# DEPARTMENT OF COMMUNITY AND ECONOMIC DEVELOPMENT

A. ADMINISTRATIVE REPORT & DECISION		
DECISION:	☐ APPROVED ☐ APPROVED SUBJECT TO CONDITIONS ☐ DENIED	
MODIFICATION DECISION:		
REPORT DATE:	August 24, 2016	
Project Name:	Finley Short Plat	
Owner/Applicant:	2525 Aberdeen, LLC, 13110 NE 177 <sup>th</sup> PI #202, Woodinville, WA 98072	
Contact:	Chad Allen, Encompass Engineering & Surveying, Inc., 165 NE Juniper St., Ste. 201 Issaquah, WA 98027	
File Number:	LUA16-000330, SHPL-A, MOD	
Project Manager:	Clark H. Close, Senior Planner	
Project Summary:	The applicant is requesting approval of a 4-lot short plat. The site is 26,311 square feet (0.60 acres) and is located at 2525 Aberdeen Ave NE and would be for the future development of three new single family homes. The property is in the Residential-8 (R-8) zoning district. The proposed residential lots range in size from 4,739 SF to 6,329 SF in area with an average lot size of 5,567 SF. The residential density is 7.8 dwelling units per net acre. Access to the lots would be from Aberdeen Ave NE via a 21-foot wide shared access tract. The native soils consist primarily of medium dense poorly graded sand with gravel underlain by recessio

sheet C2.0

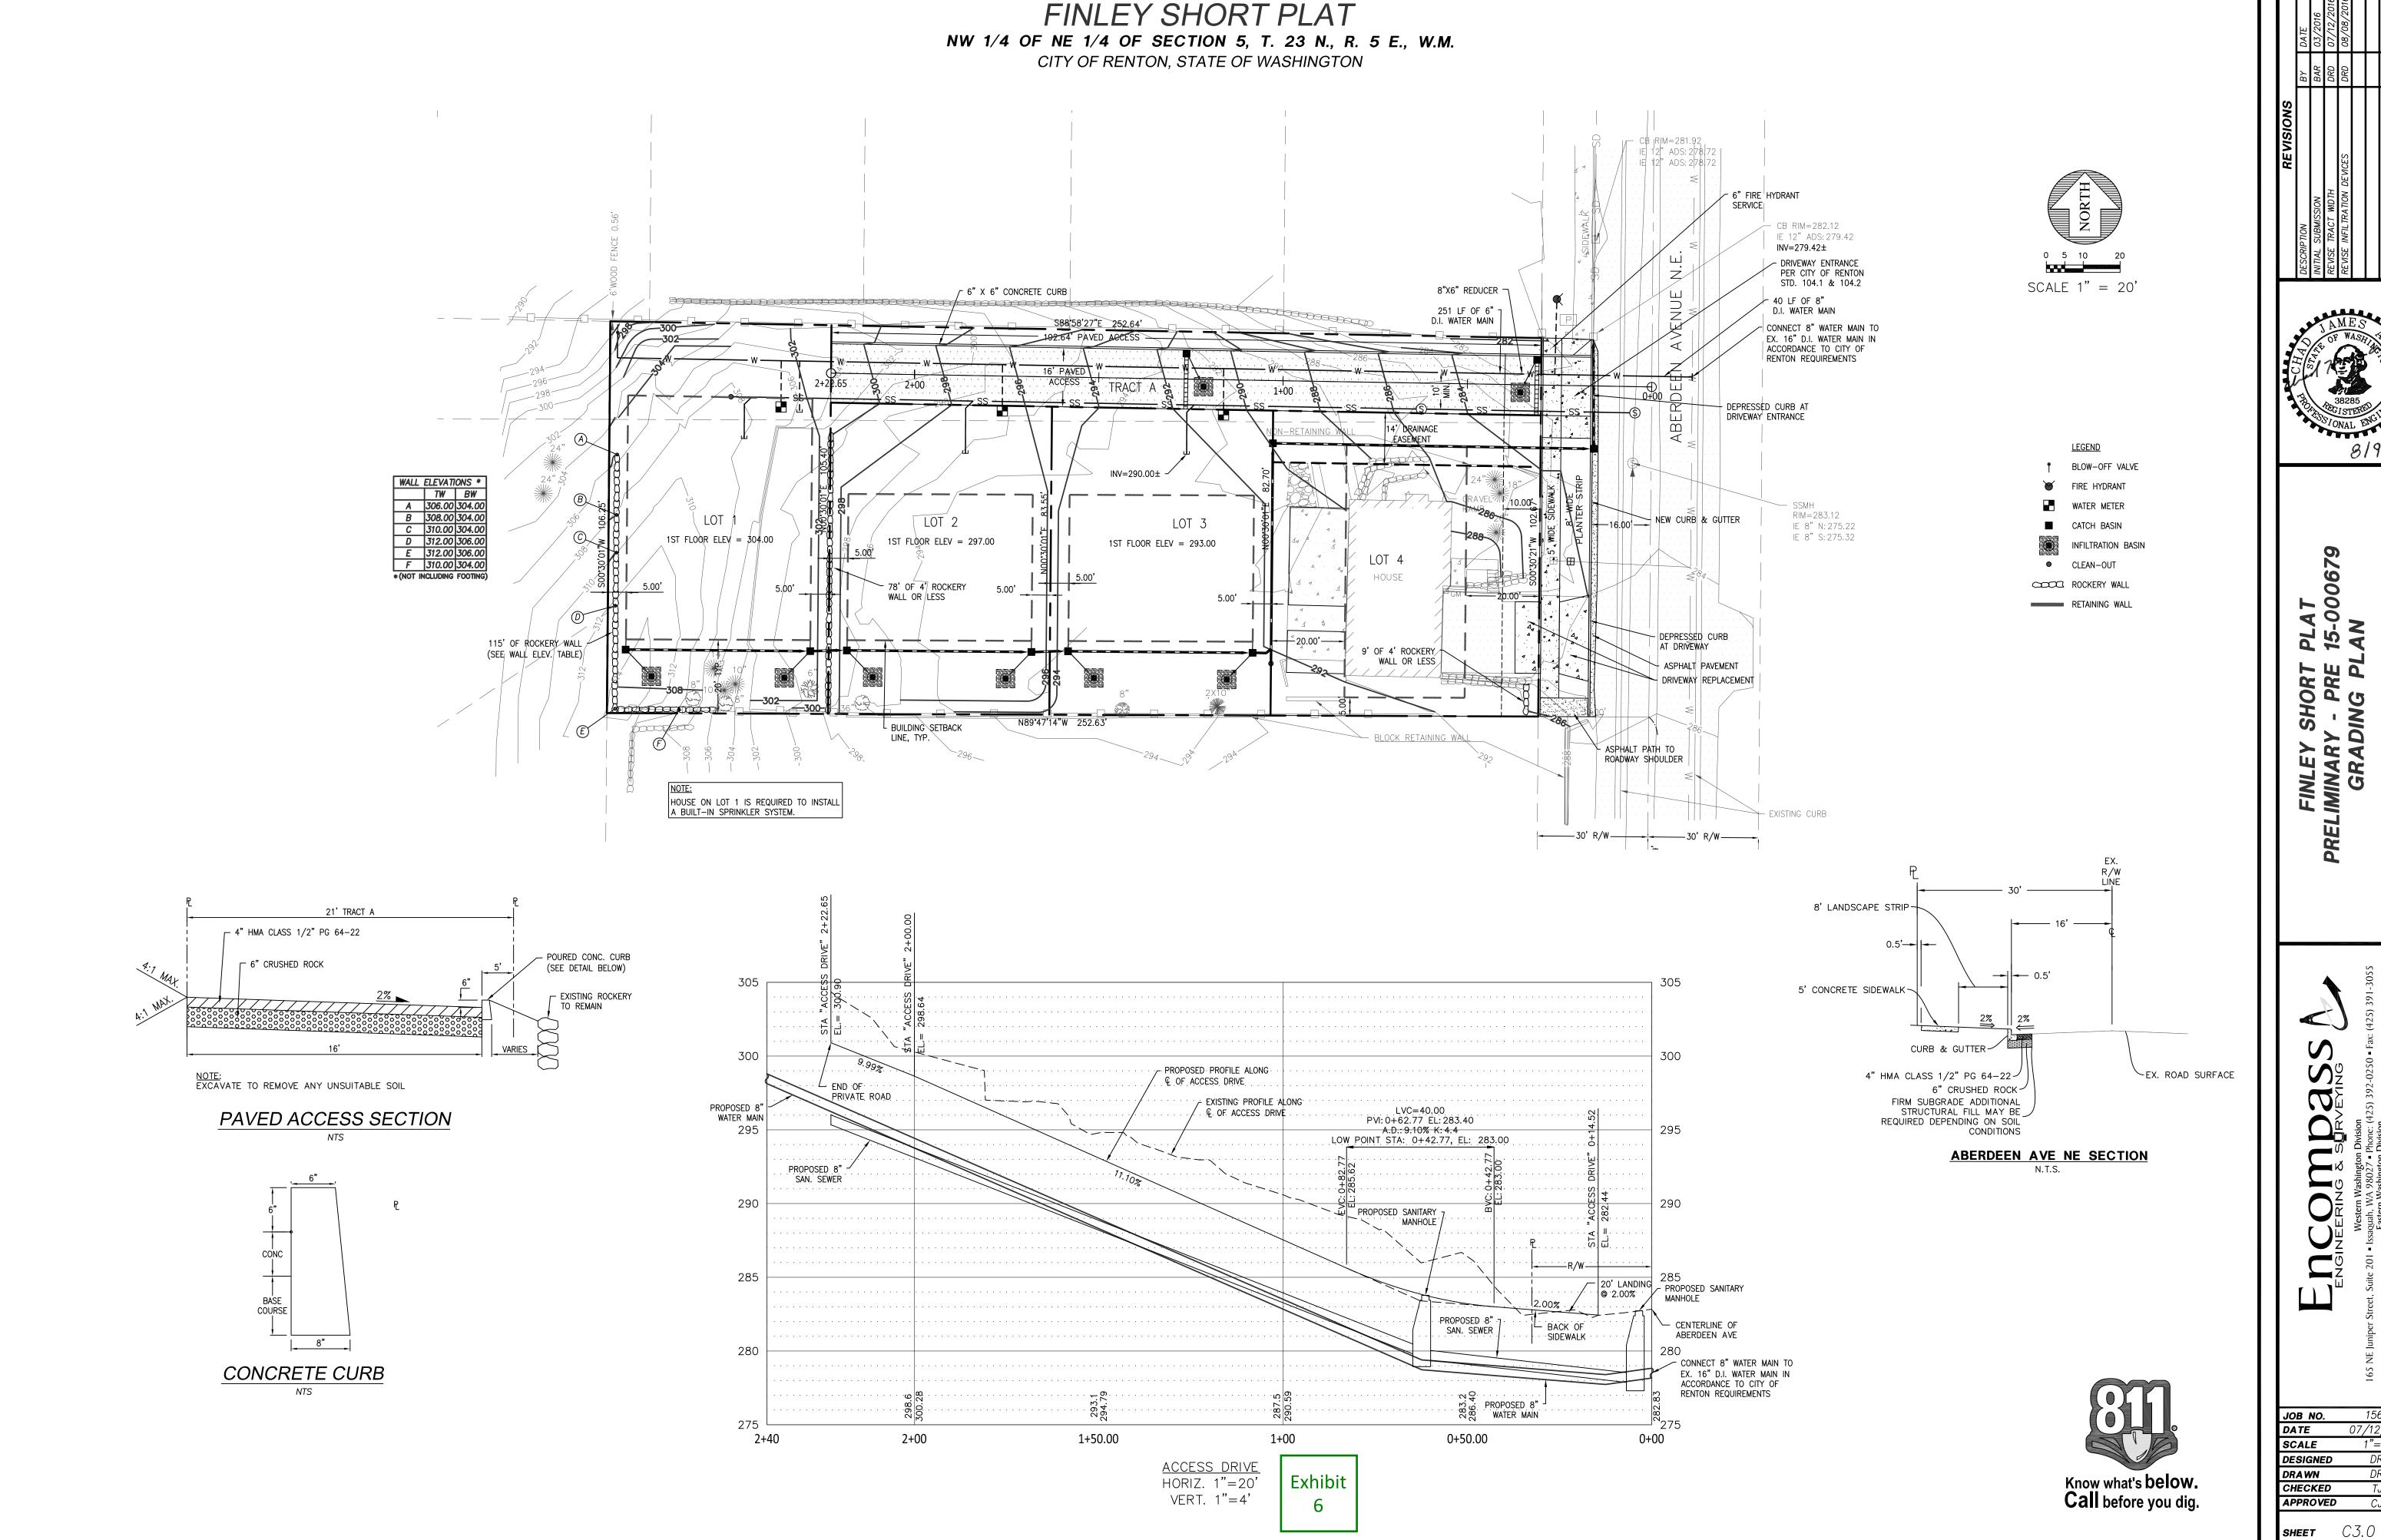
PEVISIONS
PTION
BY DATE
SUBMISSION
TRACT WDTH
DRD 07/12,
INFILTRATION DEVICES
DRD 08/08,
E PLANS SET FORTH ON THIS SHEET ARE AND SHALL REMAIN THE PROP

**SHEET** C4.0

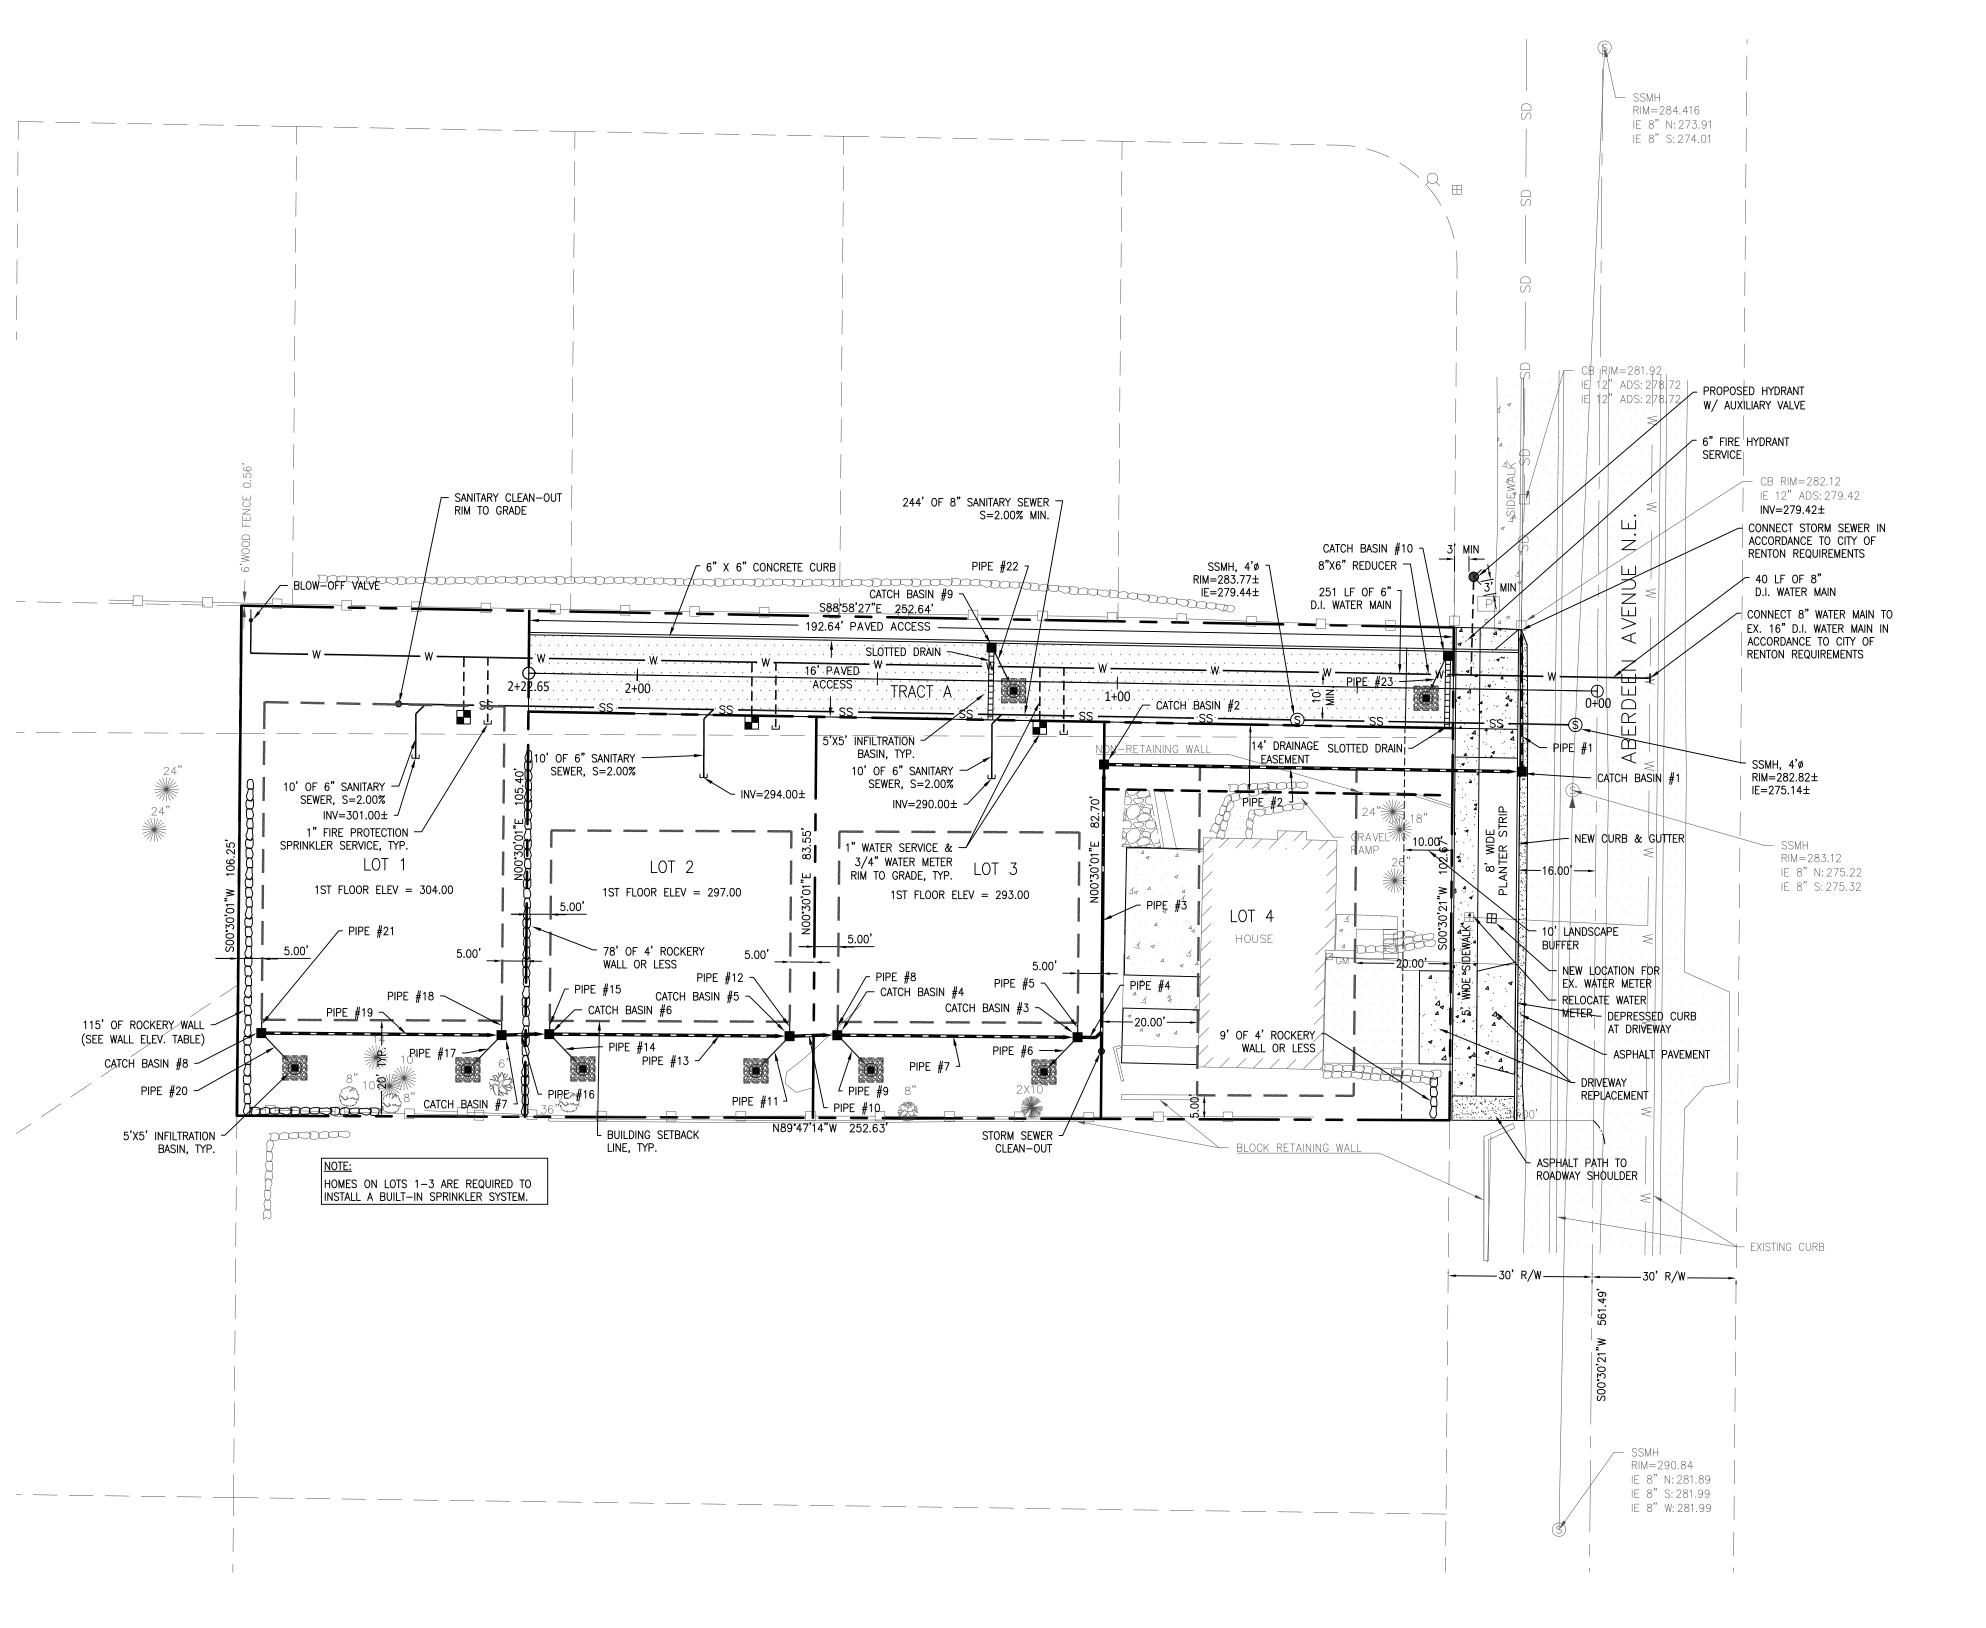
<u>Staff Comment</u> : The shared driveway exceeding eight percent (8%); therefore, the applicant is providing slotted drains at the midpoint and lower end of the driveway (Exhibit 6). Parking requirements and driveway grades for each of the new residences proposed would be verified at the time of building permit review. Driveway cuts locations and driveway width would also be verified at the time of construction permit application.
Compliant if condition of approval is met	<b>Fences and Retaining Walls:</b> In any residential district, the maximum height of any fence, hedge or retaining wall shall be seventy two inches (72"). Except in the front yard and side yard along a street setback where the fence shall not exceed forty eight inches (48") in height.
	There shall be a minimum three-foot (3') landscaped setback at the base of retaining walls abutting public rights-of-way.
	Staff Comment: No new fences are proposed. Several new retaining/rockery walls are proposed throughout the proposed development. Rockery walls exceed the maximum 48" in the front yard setback and grading shall be in accordance with RMC 4-4-060. Therefore, staff recommends that a final detailed grading plan shall be submitted to, and approved by, the current planning project manager that complies with the retaining wall standards prior to construction permit issuance.

The proposed water main improvements as shown on the composite utilities civil plan submitted with the Land Use Application within the site provides the required 8 inch extension to the fire hydrant at the proposed shared drivway and extension of the required 6 inch water main extension into the development, connecting to the existing 16 inch water main located in Aberdeen Ave NE.

- I. The existing water meter serving lot 4 shall be relocated to the new planter strip.
- II. A 3 foot clearance is required around the new fire hydrant. Verify adequate clearance can be obtained with the proposed location of the hydrant. A power vault and fence appear to potentially be within the required clearance area.
- III. Applicant shall extend the water main to the west property line for future connection to the dead end main located to the west of the subject property.
- 2. Each lot shall have a separate meter. The project proposes one 3/4 inch water service line and meter to each lot, for a total of three (3) new domestic water service lines and meters.
